# This document is received on 15 MAY 2025 The Town Planning Board will formally acknowledge the date of receipt of the application only upon receipt of all the required information and documents. APPLICATION FOR PERMISSION UNDER SECTION 16 OF THE TOWN PLANNING ORDINANCE (CAP. 131)

For Official Use Only 請勿填寫此欄	Application No. 申請編號	A/11-KIN/1118
	Date Received 收到日期	1 5 MAY 2025

# (S.16 Planning Application No. A/YL-KTN/1118)

# Annex I – Response to the Comments of Chief Engineer/Mainland North, Drainage Services Department (CE/MN, DSD)

VIEW 2 FINAL DISCHARGE POINT

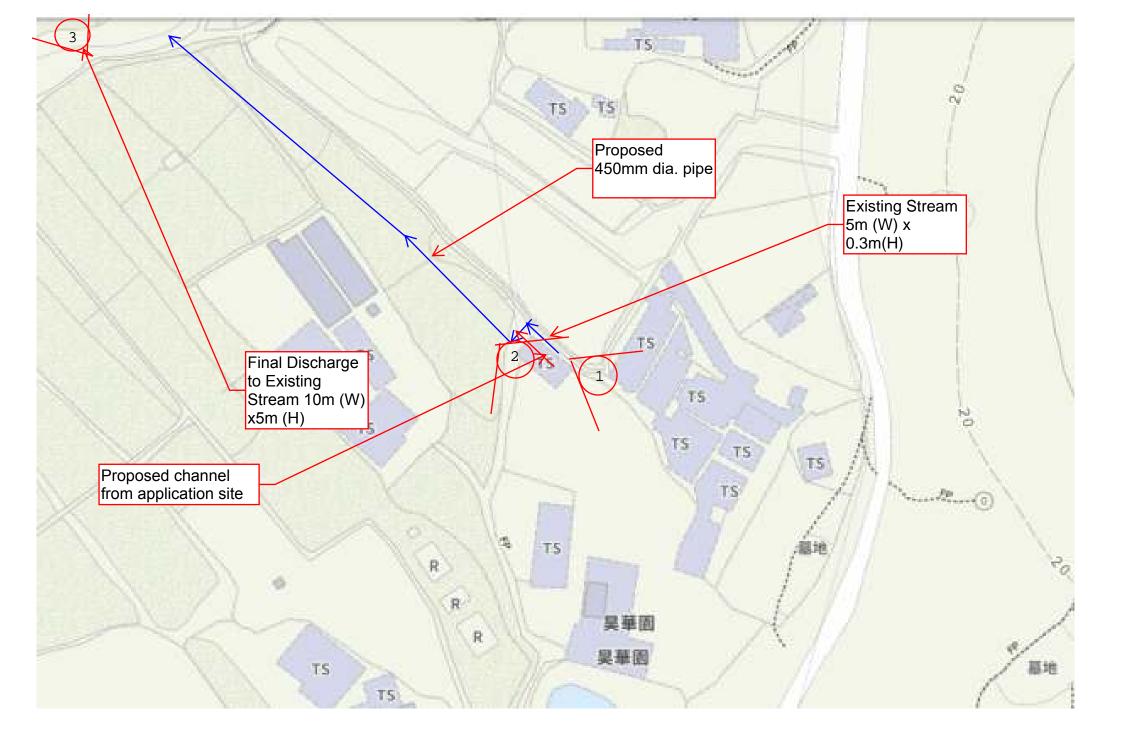
(4)	Please clarify the relationship between view 2 and view 3. It is noted that there are already few underground pipes in view 3, please clearly advise how the proposed discharge pipe would not affect the existing underground pipes.	Underground pipe will be reconstructed as 450mm dia. UPVC due to insufficient capacity of original pipe (Annex I).

Figure 1a. Drainage Layout (Con't)

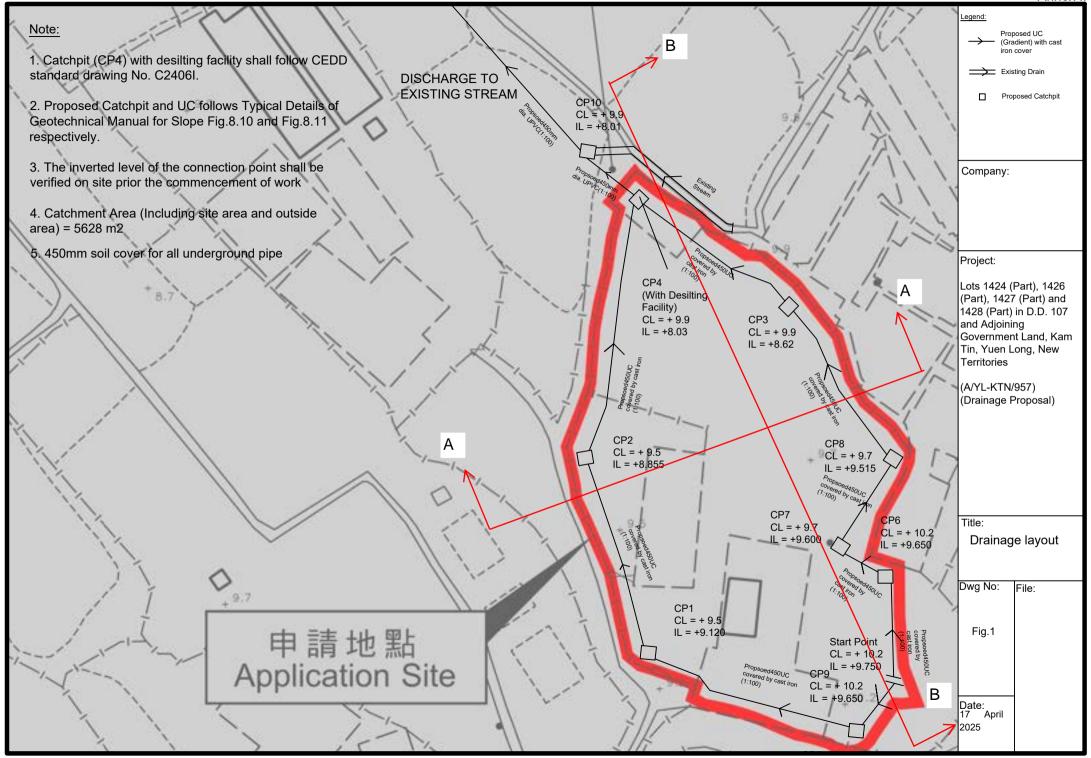
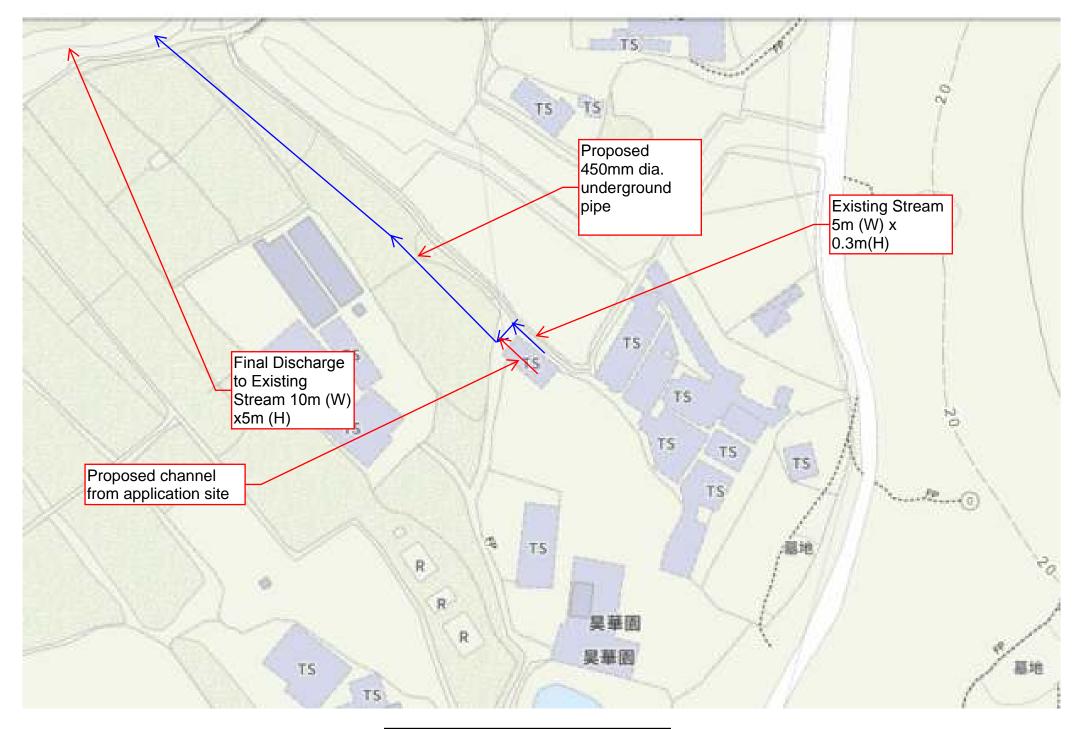
(2)	Fig 1 and the page after Fig 1 – The size of proposed underground pipe is inconsistent;	Noted and revised accordingly (Annex II).		
(3)	Connection details - CP9 is not connecting to existing stream as shown in the drainage layout plan. All proposed invert levels including the final discharge level should be given;	Noted and revised accordingly (Annex II).

Fig.8. Eye Location Plan for Site Photo

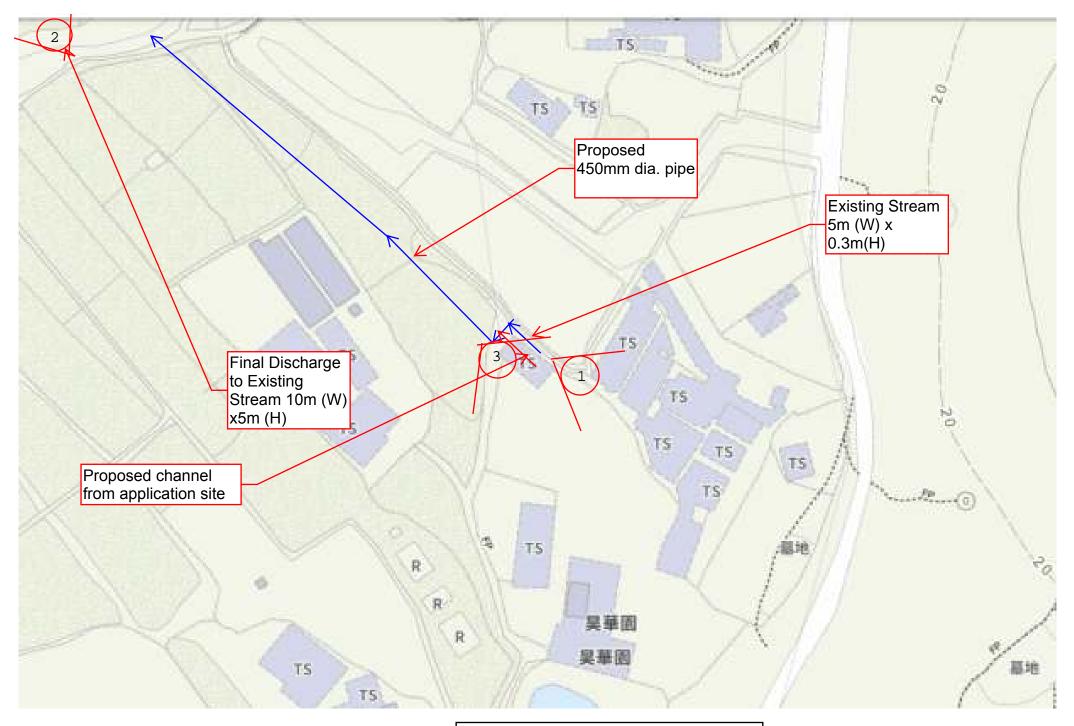
(4)	Calculations – Please justify why runoff coefficient 0.4 is taken;	Noted. The Runoff Coefficient is justified in Figure 2 (Annex II).		
(5)	Please review if view 2 and view 3 are correctly shown the right location;	Noted and revised accordingly (Annex II).

Figure 1a. Drainage Layout (Con't)

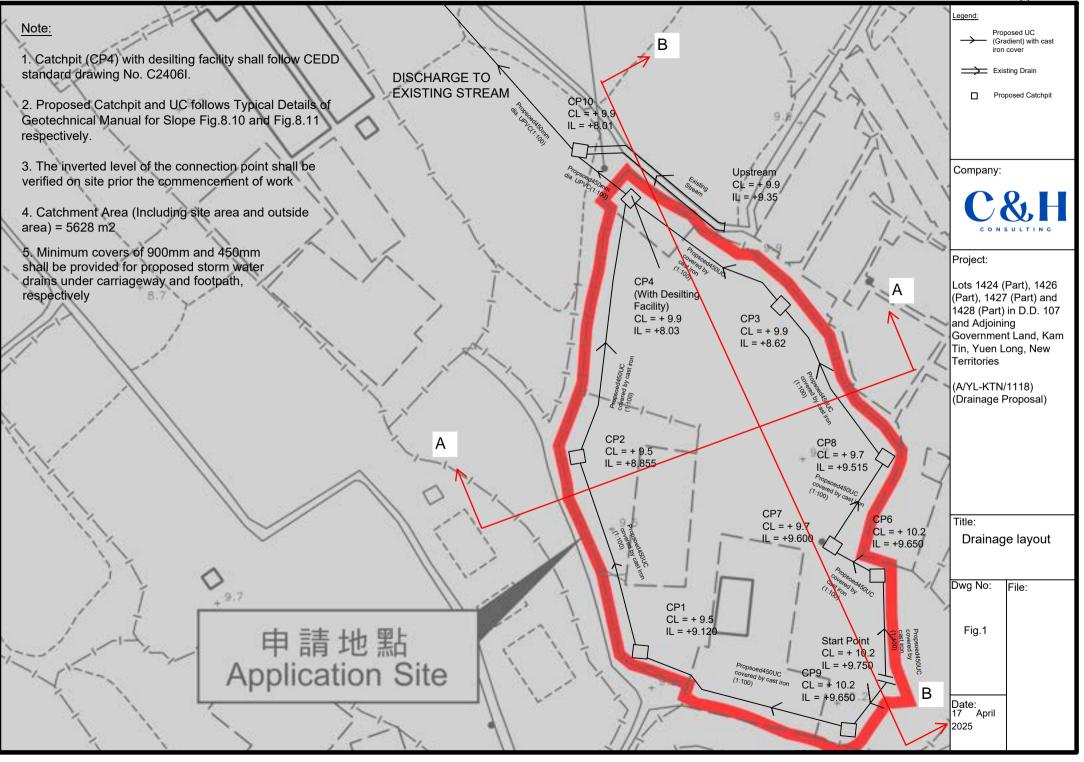
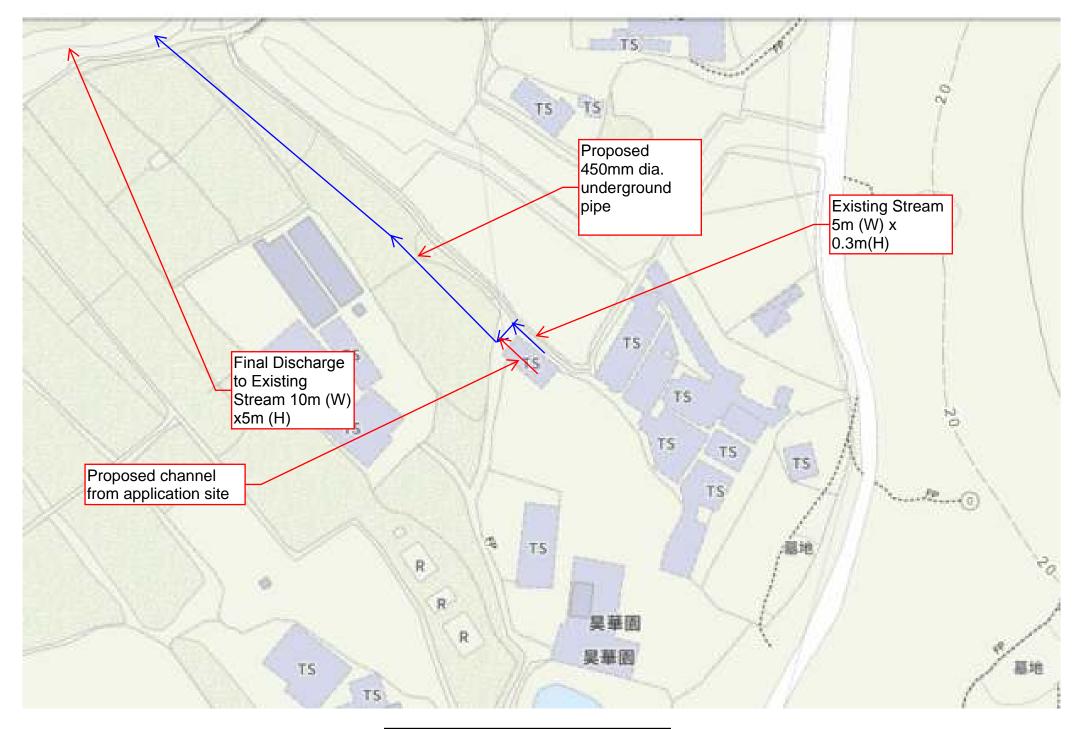
Comr	Comments of the CE/MN, DSD							
(Cont	(Contact Person: Ms. Jessica KWAN; Tel: 2300 1144)							
(1)	Figure 1 & 7: The applicant should clarify invert levels of existing streams at the upstream and downstream of the proposed catchpit CP10. Invert levels of the drainage facilities at the upstream shall be higher than that at the downstream;	Invert level of captioned drainage facilities has been provided in Fig.1 and Fig.7 (Appendix II).

DRAWING NO. C2406 /2A

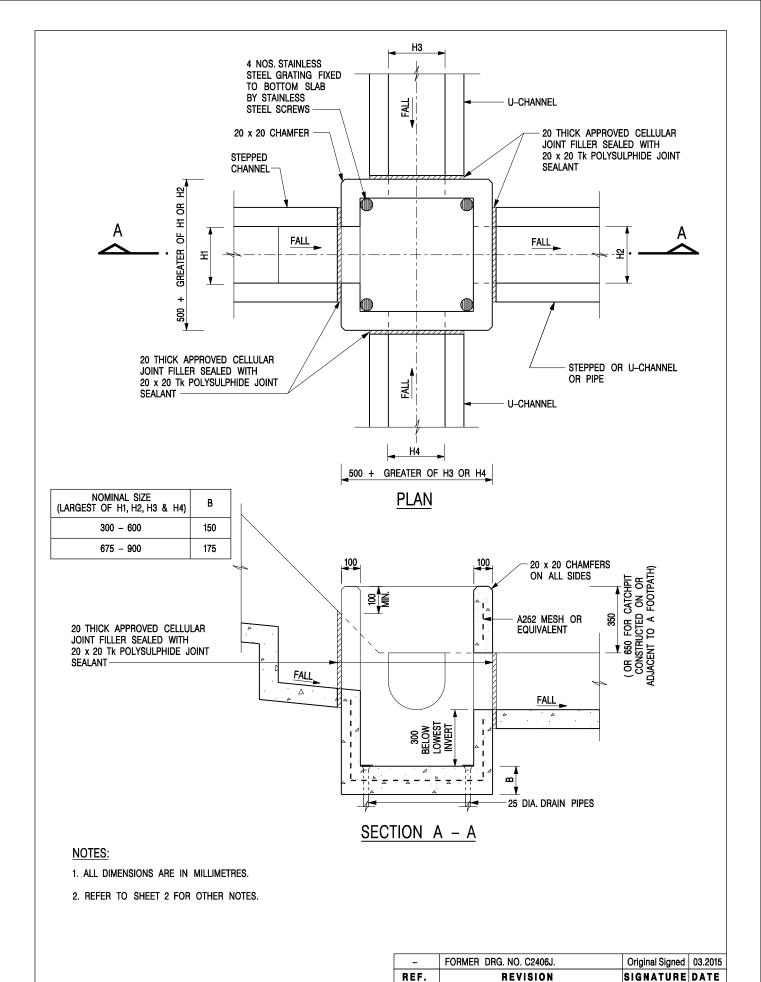
(4)	Drawing (No.: C2406/2) enclosed in the submitted proposal is not up-to-date;	The drawing is according to CEDD standard drawing, based on website: https://www.cedd.gov.hk/eng/publications/standards-spec-handbooks-cost/standards-spec-handbooks-cost/standards-spec-handbooks-cost/standards-spec-handbooks-cost/standards-spec-handbooks-cost/standards-spec-handbooks-cost/standards-spec-handbooks-cost/standards-spec-handbooks-cost/standards-spec-handbooks-cost/standards-spec-spec-handbooks-cost/standards-spec-spec-handbooks-cost/standards-spec-spec-handbooks-cost/standards-spec-spec-handbooks-cost/standards-spec-spec-handbooks-cost/standards-spec-spec-handbooks-cost/standards-spec-spec-spec-spec-spec-spec-spec-spe
